Stormwater Best Management Practice (permanent) Certification Letter

October 16, 2020

RE: **Flying Horse North Filing No. 1**

DETENTION FACILITY NO. 8 DUAL 60" RCP CULVERTS / FOREBAY DESIGN

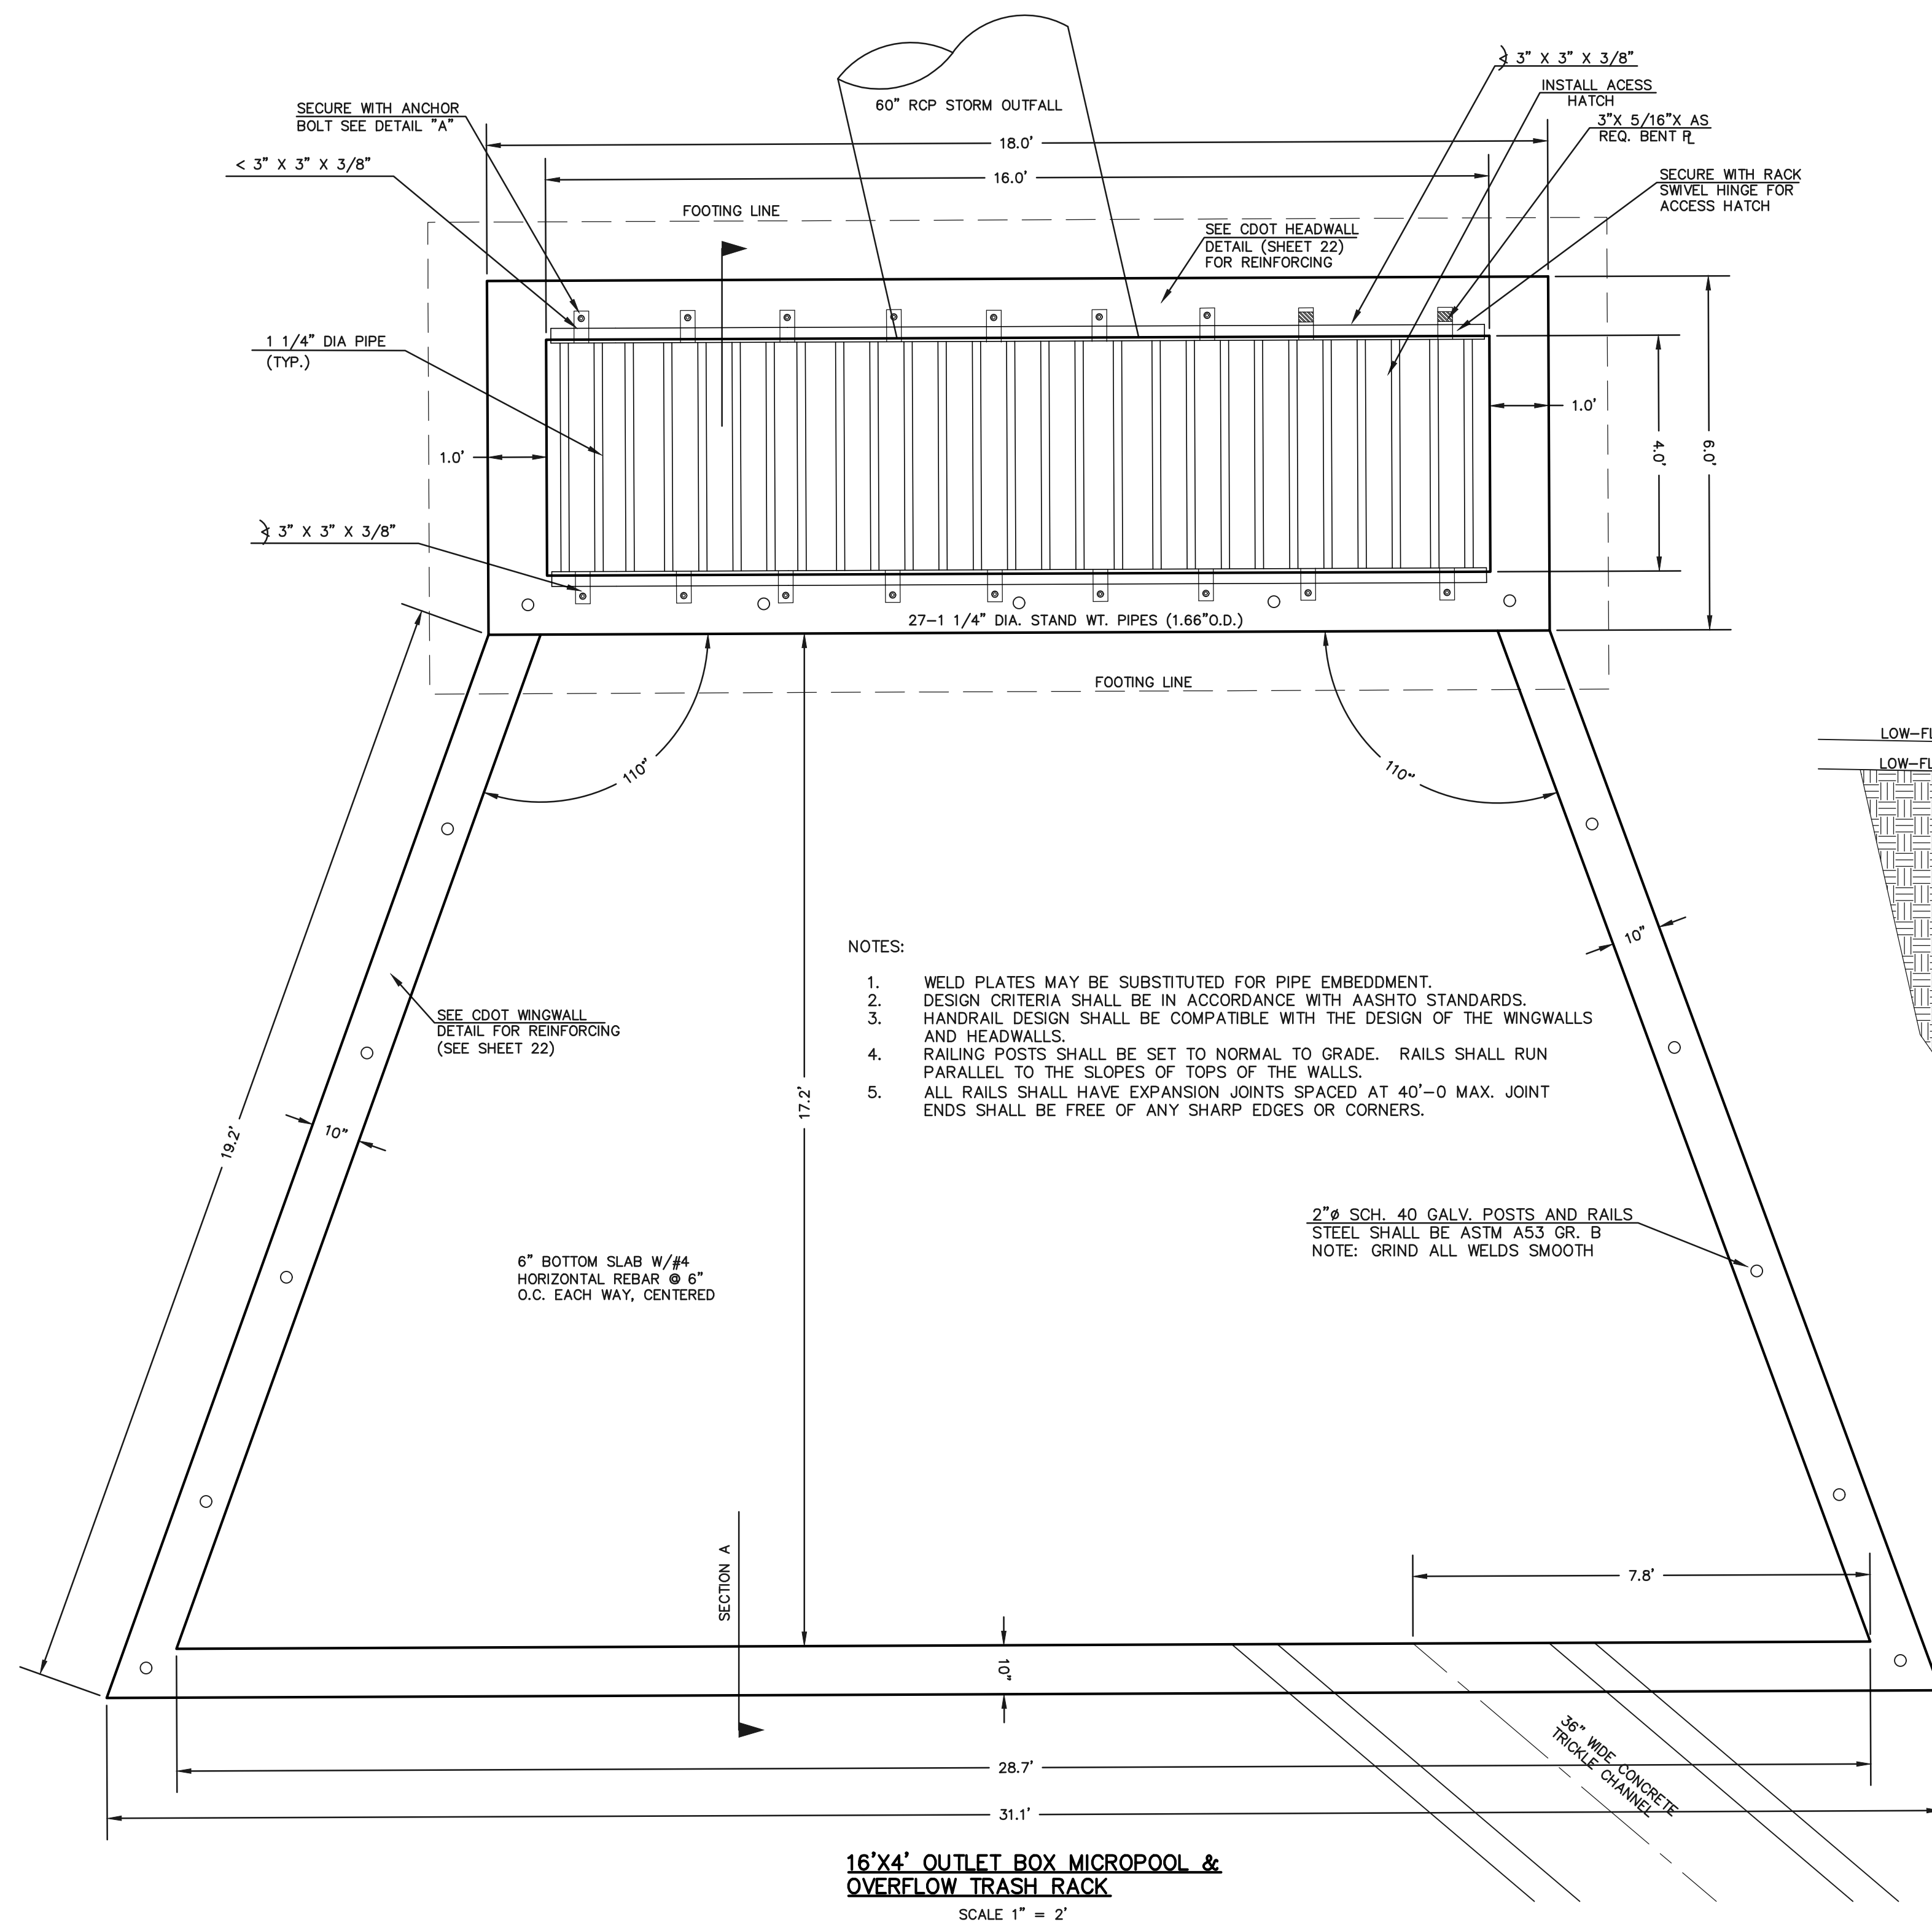
Specifically to forebays: most of the forebays for each pond have significant enough changes from design to as-built condition. So please confirm with calcs that forebay volume is not less than the required volume shown on the UD-BMP spreadsheets submitted with the original FDR. Because for most forebays no extra capacity was provided as a buffer (although some show at most 0.001 ac-ft extra volume, which might be enough).
